Docket Item #6 & #7 BAR
CASE # 2016-0425 &
2016-0426

BAR Meeting
January 18, 2017

ISSUE: Partial Demolition and Alterations

LOCATION: 724 South Fairfax Street

Figure 1: Chimney

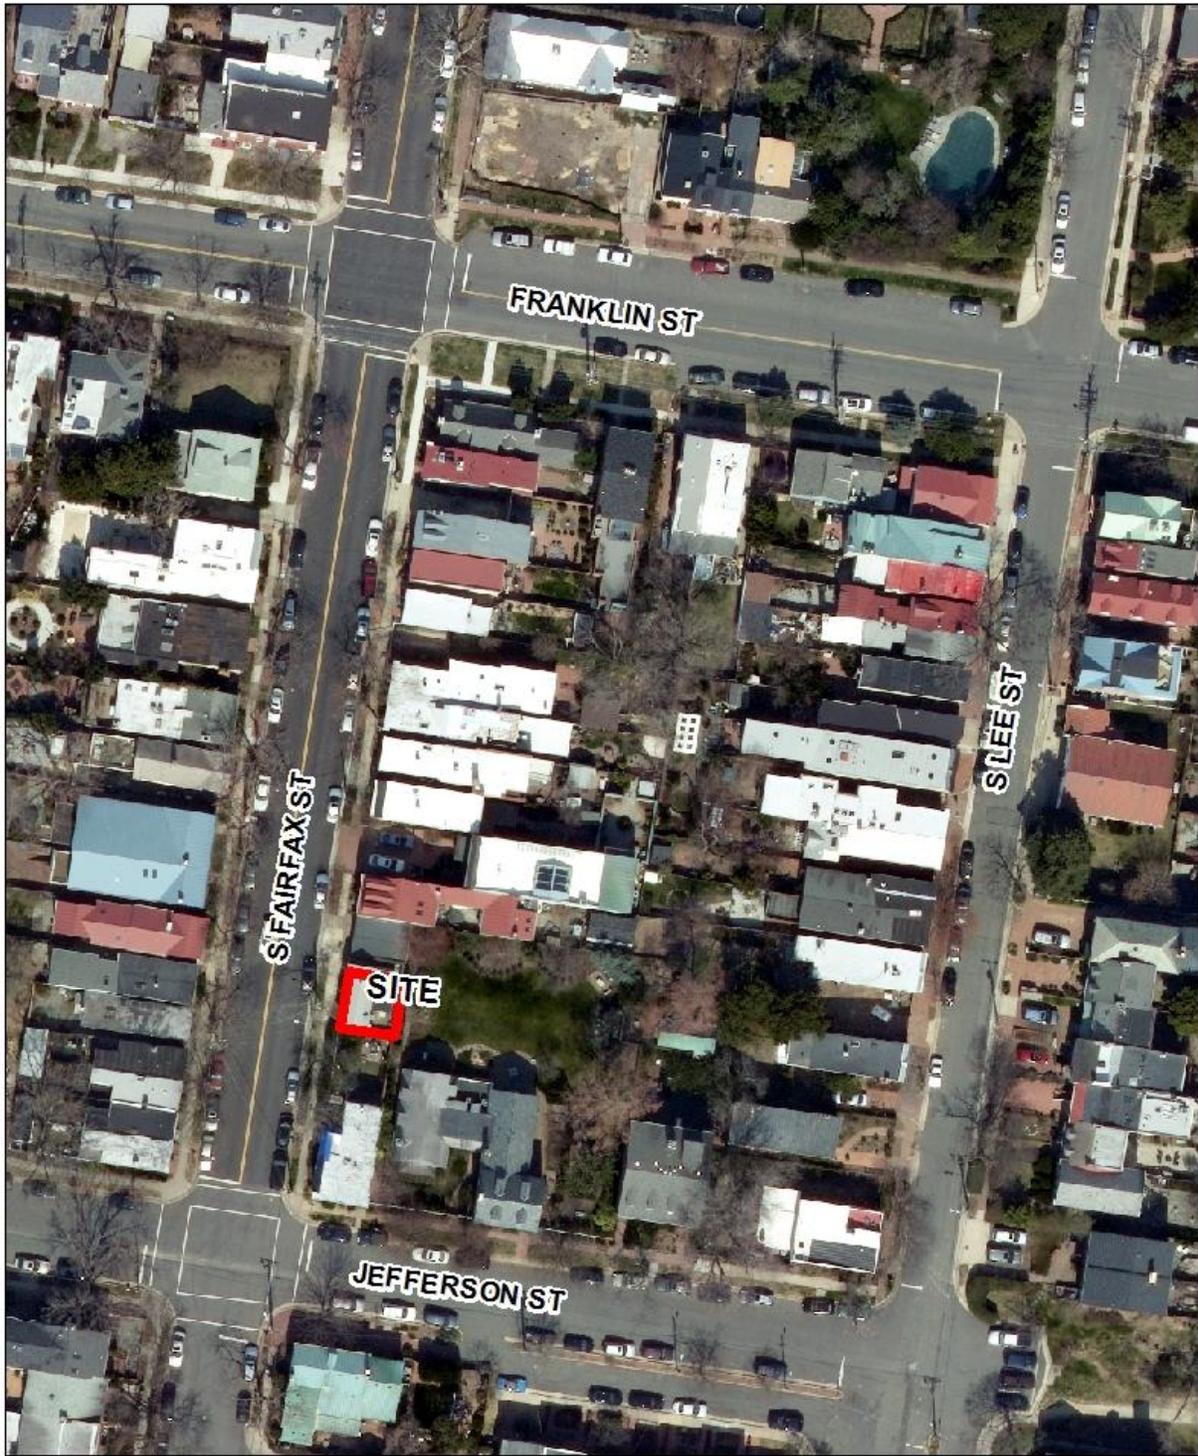
While chimneys are considered one of the character defining features of early houses, the extant chimney (Figure 1), with its hard fired brick and Portland cement mortar, does not appear to date to the building's original period of construction. In the opinion of staff, the current chimney's demolition will not remove any portion of the building containing character-defining features of uncommon design or cultural or architectural merit and will not compromise the integrity of the building as a whole. Therefore, staff recommends approval of the Permit to Demolish.

Figure 2: Elevations not visible from public way

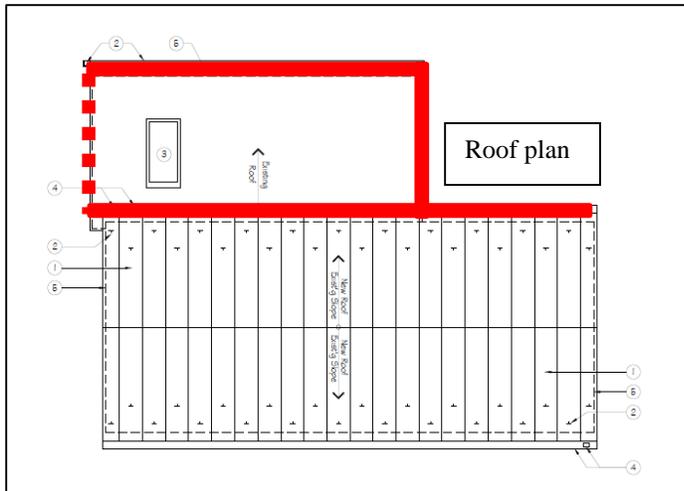
While staff routinely approves replacement materials administratively on historic buildings when the new materials are historically appropriate and comply with the BAR's adopted policies, the applicant proposes to use synthetic materials which require the approval of the Board. Although approval of some of the proposed alterations to 724 South Fairfax could have been achieved through the administrative approval process, they are included here so that the Board can see the comprehensive alterations proposed by the applicant and to reduce the application fees. The Board's approval authority is limited to the front and side elevations of the main block of the house because staff has determined that the other elevations of the house are not visible from the public way (figure 2). Although the north elevation of the one-story rear addition is partially visible (dashed line in figure two), it is only minimally visible and of later construction, so staff can support the use of synthetic materials on this elevation.

1 Proposed Front Elevation
 Scale: 1/4" = 1' - 0"

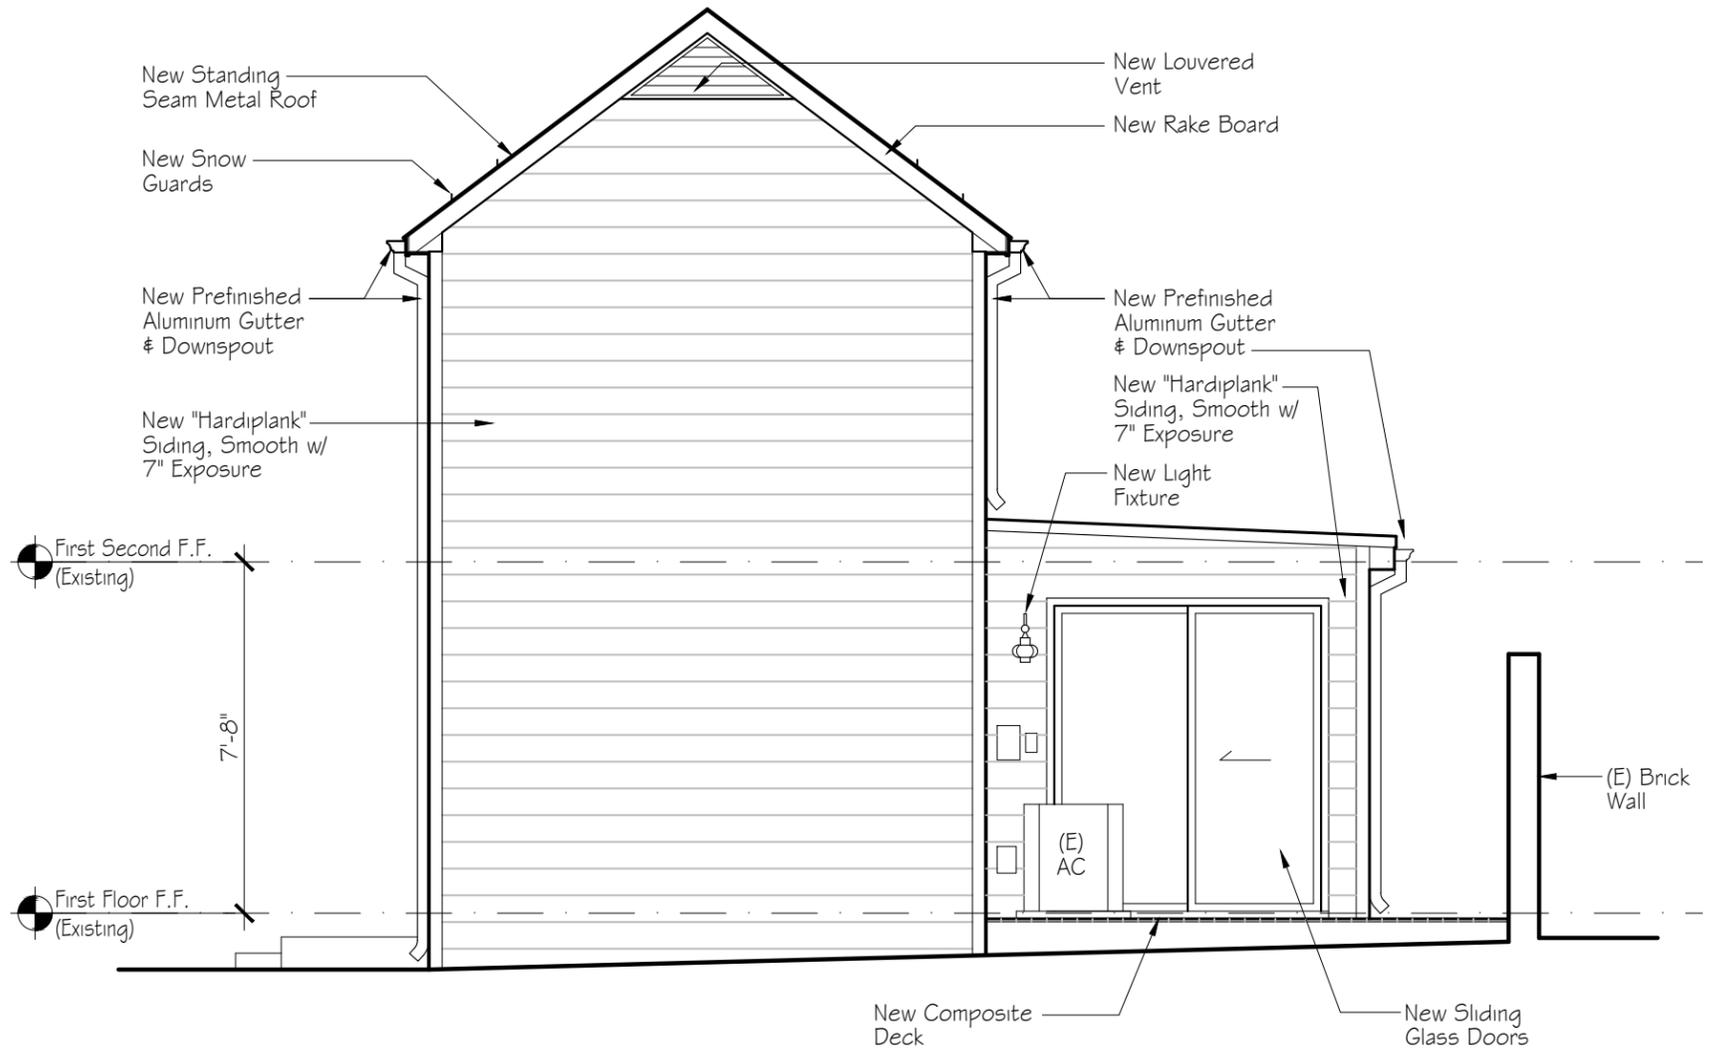
However, staff does not support the use of HardiePlank synthetic siding or aluminum clad windows on the main building block. Although modest in scale and design, the subject property contributes to the evolving streetscape of the southern quadrant of Old Town, and the use of historically appropriate materials on the main block, which is located on the front property line where the materials are subject to close inspection, is essential to retaining the integrity of this early building.

For these reasons, staff recommends that the Board deny the use of aluminum clad windows on the front façade of the main block, and instead approve painted wood windows, with single-glazed windows on the street-facing façade (these may have either a removable double glazing panel or storm windows) and simulated-divided-light painted *wood* windows on the visible secondary elevations. The replacement windows must also meet the *Alexandria Replacement Window Performance Specifications*. The windows and siding on non-visible elevations may be any material permitted by the building code.
